Nebraska Capitol Environs Commission Agenda

APRIL 26, 2018

3. [Ground sign for Lincoln High School](#), 2229 J Street on Capitol Parkway. - ([UDR18027](#))
4. [Renovations at University Lutheran Chapel](#), Centennial Mall at 1510 Q Street. - ([UDR18026](#))

Lutheran Chapel, east facade

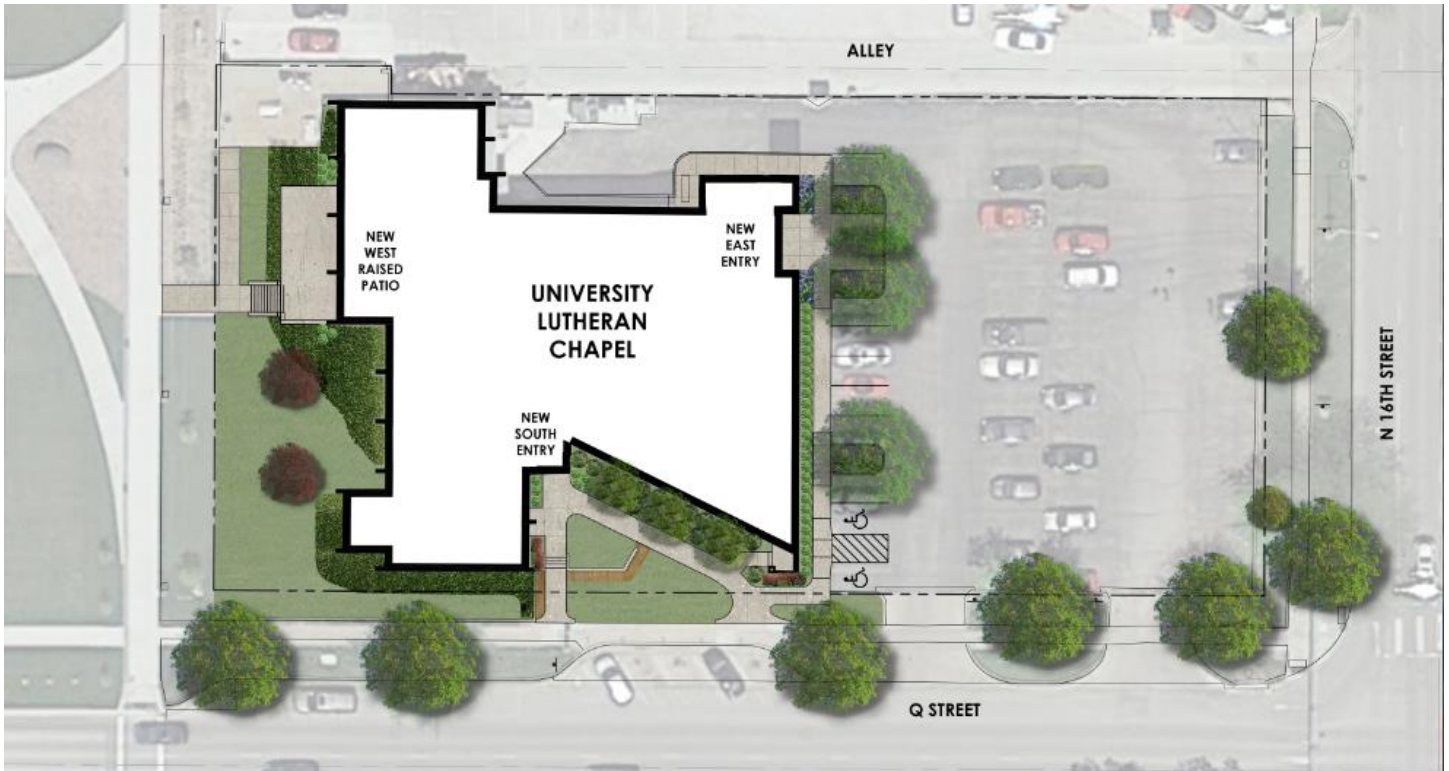
The east side of the property is a parking lot, while the east façade of the Chapel is currently a nearly featureless brick wall with a subtle receding portion, opening "slot" windows to the sanctuary within.

The renovation plans note that the east brickwork is in need of repair and a direct entrance from the parking lot is desired. The proposal would redesign the recessed portion of the wall with new materials, more windows, and a new east entrance. Design Standard 9: Facades includes *“In the rehabilitation of existing buildings, retention of high quality materials and use of new, durable, and high quality materials is...desireable.”*

The Design Standard on this façade (not facing Capitol Square or a Mall) would be to generally enhance the district. The new proposal is certainly more inviting and adding some landscaping to the parking lot would be very welcome.

South entrance, current (left) and proposed (right)

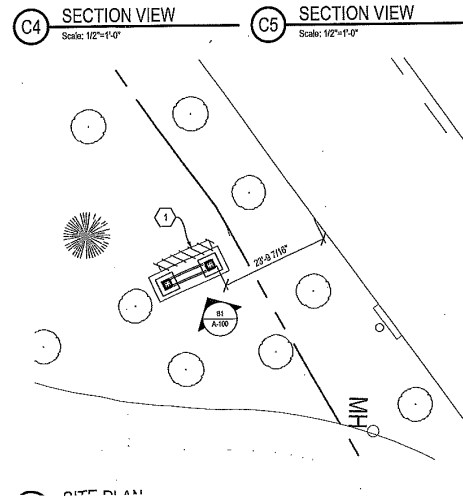
The new south entrance is intended to announce that entrance visually and especially to remedy water problems inherent in the present design, which drains large roof surfaces down toward that recessed entrance. A new entrance “tower” would also include an elevator for accessibility within the Chapel. The proposal echos the shed roofs and simple geometric forms of the original design, while articulating the entrance much more clearly. Design Standard 9: Facades mentions *“Special...uses (such as churches) present opportunities for buildings of*

greater individual prominence than is otherwise desirable along the Malls or facing Capitol Square.”

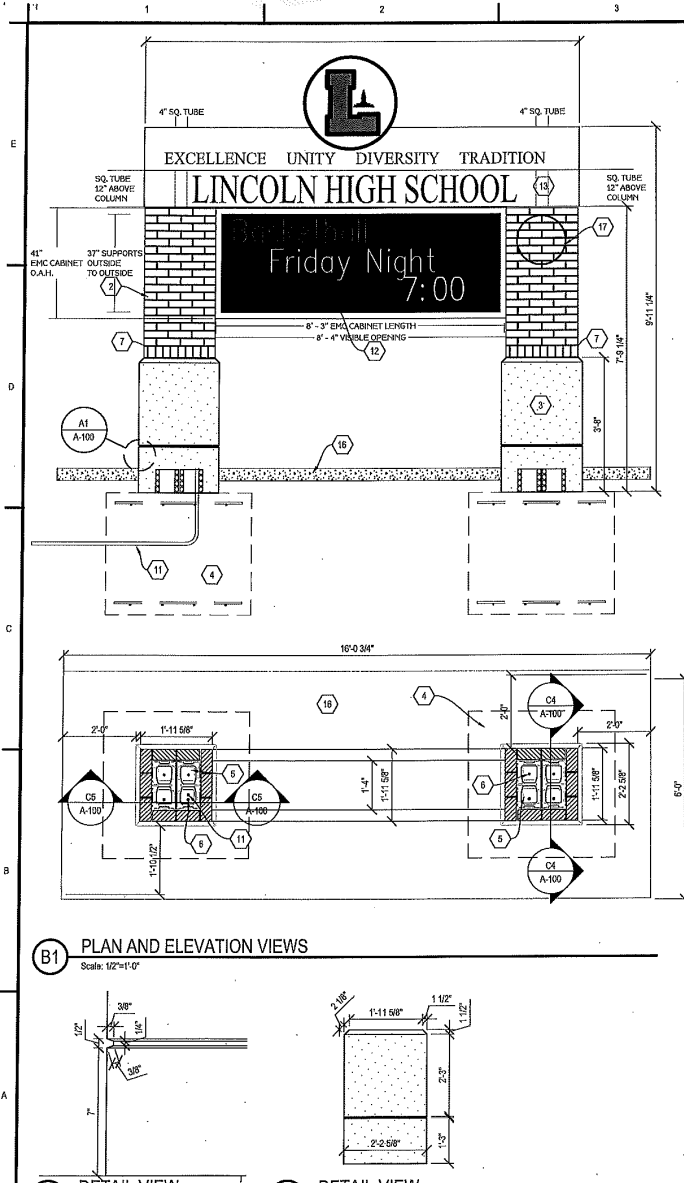
Lincoln High School has a tall freestanding sign with digital message panels north of the building, along the parking lot on the Capitol Parkway frontage. The sign is approximately 20 feet tall, standing on two metal poles.

LPS and Lincoln High request a certificate of appropriateness to install a replacement sign consisting of two brick piers on cast stone bases, with electronic display boards below an aluminum sign cabinet top, with vinyl inscriptions and white LED illumination. The electronic portion would be 41"x8'3"; the overall height (exclusive of logo) would be just under 12' tall.

The brick piers of the proposed sign are specified to match the color of the buff brick of the high school. The cast-stone piers will be similar in color to the terracotta trim of the 1913-15 portion of Lincoln High. The lower height of the sign should actually offer greater visibility as the street trees along Capitol Parkway have grown to largely block the taller existing sign.

The Commission's Design Standard 6: Signs addresses "overall compatibility, durability, and high quality." The proposed sign in height, materials, and design seems to meet that standard and to warrant a Certificate of Appropriateness. (See attached plan sheet for Notes and dimensions.)
